Interactive comment on “Fast NO₂ retrievals from Odin-OSIRIS limb scatter measurements” by A. E. Bourassa et al.

Anonymous Referee #1 Received and published: 13 January 2011

Fig. 1. Revised Figure 5

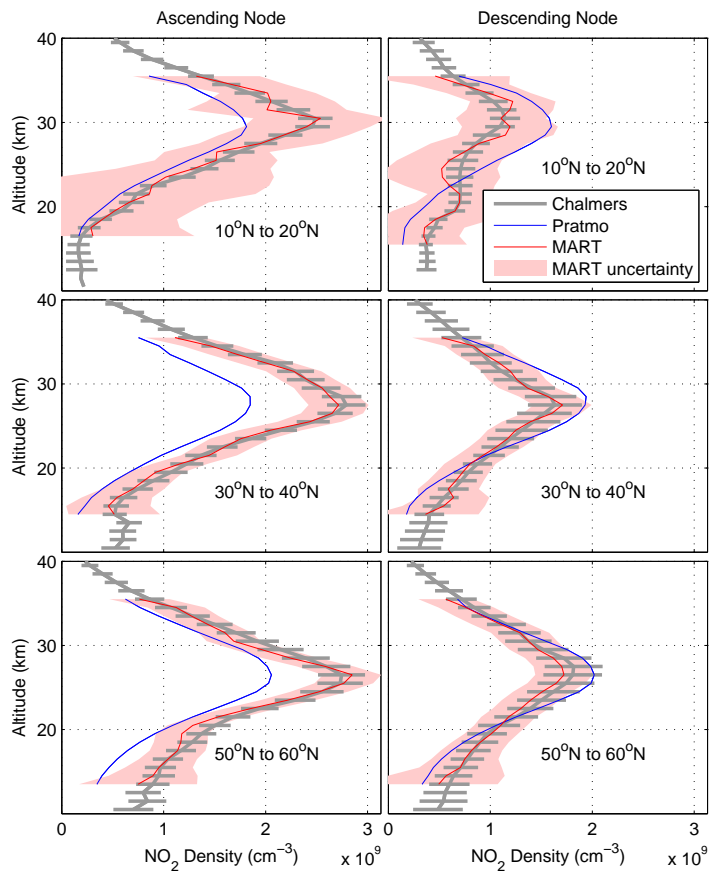
1. There is no discussion whatsoever about the error estimates of the new nor the official NO₂ product.

The figure below is a revision of Figure 5, which now includes the precision of the new MART retrieval (in the red shading) in addition to the error estimate from the official NO₂ product (in gray bars). The error bars shown on the profile are the average uncertainty for each of the average profiles (and not the error in the average profile). Thus these error bars show the typical error for a single retrieved profile in each of the latitude bins. As expected, the uncertainty in the MART retrievals is systematically larger than that in the official product. However, for mid and high latitudes where the signal to noise is high due to the smaller solar zenith angles at the tangent point, the MART error bars are much less than a factor of two larger those of the official product. However, in the tropics where the signal to noise is decreased, the MART uncertainty can be several times larger than the uncertainty in the official product.

Fig. 2. To become Figure 6

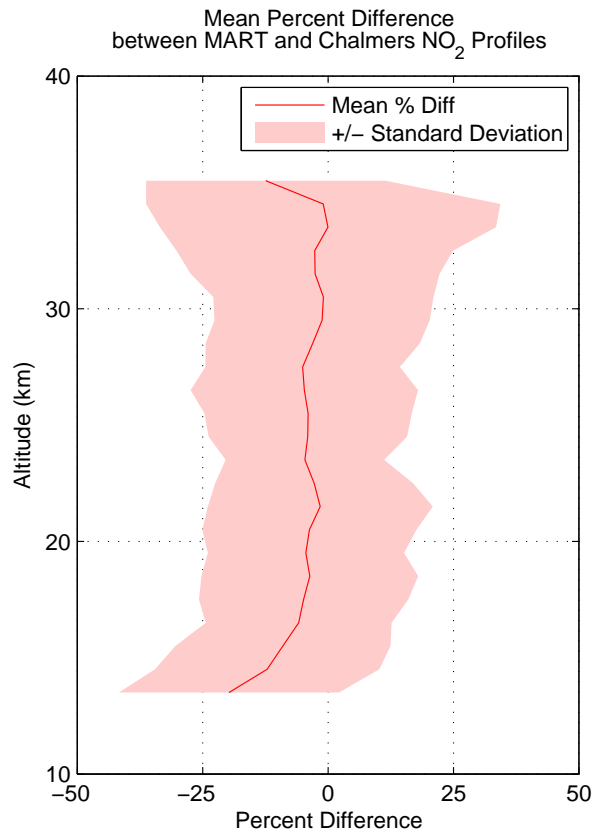
2. Fig 5. Instead (or additionally) of the zonal means, the authors should compare individual profiles and plot the mean/median (and deviation) of the individual relative differences for different latitudes/nodes.

As suggested, we have included a new figure (below) that shows the statistics from the comparison of all individual profiles from the full day of retrievals. The mean of the percent difference from each comparison does not show any bias and is within a few percent of zero from 14 km to 34 km. The standard deviation of the comparison is approximately 20% at all altitudes. This is somewhat high, however, it simply reflects the size of the error bar in the NO₂ retrieval as shown in the previous figure.
